Bituminous Interim Inspection

PROJECT NUMBER	B190846/1	AREA MANAGER	John Wilkinson
PROJECT NAME	Paterson Building - Christie Hospital		
PROJECT ADDRESS	Christie Hospital, Wilmslow Road, MANCHESTER Lancashire M20 4DJ		
APPROVED CONTRACTOR	Primeseal Roofing Ltd		
TEL	0161 620 7557		
SITE CONTACT FOR ABOVE	Stephen Duffy (0161 620 7557)

Roof No.	Roof(s) Inspected	% Complete	Roof Area Name	Size	System	ID (Office Use Only)
RA 1	X	95	RT09_01 - Section 1	340.00	BTRS	940

Photo 4 - View of cap sheet to section 3

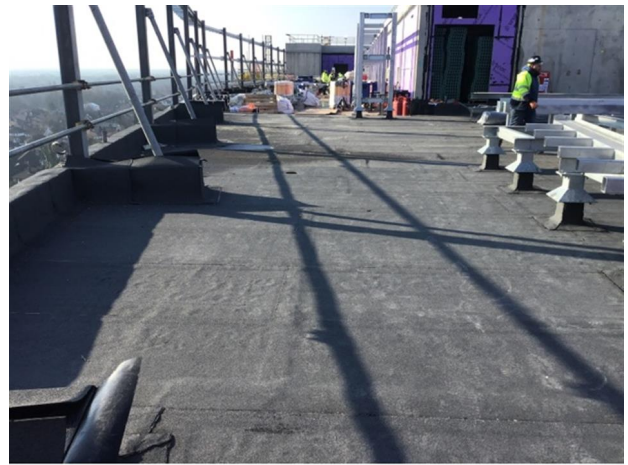
Level section 3 has been passed for landscaping
